Request for an Interpretation of a Reliability Standard	
Date submitted: March 25, 2009	
Contact information for person requesting the interpretation:	
Name:	James A. Ziebarth T. William Middaugh
Organization: Y-W Electric Association, Inc. Tri-State Generation & Transmission Association, Inc.	
Telephone:	(970) 345-2291 (303) 254-3433
E-mail:	james@hea.coop bmiddaugh@tristategt.org
Identify the standard that needs clarification:	
Standard Number (include version number): PRC-004-1 and PRC-005-1	
Standard Title: Analysis & Mitigation of Transmission/Generation Protection System Misoperations; Transmission & Generation Protection System Maintenance & Testing	
Identify specifically what needs clarification	
Requirement Number and Text of Requirement:	
In Standard PRC-004-1:	
<p>R1. The Transmission Owner and any Distribution Provider that owns a transmission Protection System shall each analyze its transmission Protection System Misoperations and shall develop and implement a Corrective Action Plan to avoid future Misoperations of a similar nature according to the Regional Reliability Organization's procedures developed for Reliability Standard PRC-003 Requirement 1.</p> <p>R3. The Tr

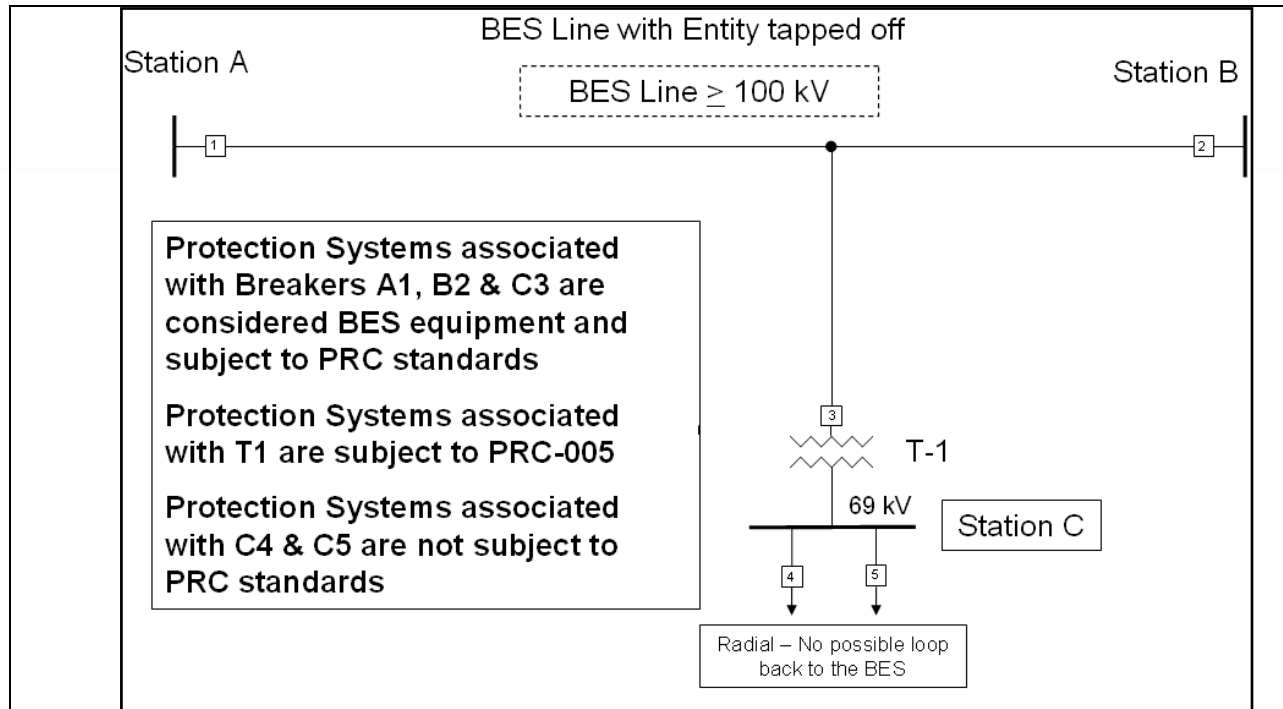
There is some debate as to what constitutes a transmission Protection System, versus any other Protection System. For example, consider a tap from a looped 115 kV transmission system where this tap consists of a step-down power transformer and its associated distribution system. The Protection System includes the transformer protection equipment (overcurrent and differential relaying with a circuit switcher) and the associated distribution system protection equipment (usually reclosers). For this example, all connected distribution facilities are designed to be radial in nature and are normally operated radially, with only the possibility of being briefly connected in parallel with other distribution facilities during switching to feed this load from another substation while this substation is taken out of service.

In this example, the looped 115 kV transmission system may be part of the Bulk Electric System and its protective relays and breakers located at the endpoints of this line section would be considered transmission Protection Systems and be subject to these standards. The status of the transformer protection equipment is unclear, though. The protective relays and the circuit switcher are connected at or attached to equipment that is connected at 115 kV, but this equipment is essentially connected to the BES radially, serves radial load, and is not necessarily designed to

protect the transmission system to which it is connected. In fact, in many cases this equipment is designed strictly to protect the transformer from overloads and through-faults relating to the connected distribution system as well as to minimize transformer damage resulting from internal faults by rapidly de-energizing the transformer for such internal faults.

Y-W Electric Association, Inc. (Y-WEA) and Tri-State Generation and Transmission Association, Inc. (Tri-State) respectfully request an interpretation of the term "transmission Protection System" and specifically whether protection for a radially-connected transformer protection system energized from the BES is considered a transmission Protection System and is subject to these standards.

In general, a radially connected transformer protection system energized from the BES would not be considered a transmission Protection System. In the event that the transformer low side is connected to a potential source (generator or networked low side system) and there are Protection Systems installed to detect and initiate actions for transmission system faults, then these Protection Systems would be considered transmission Protection Systems.
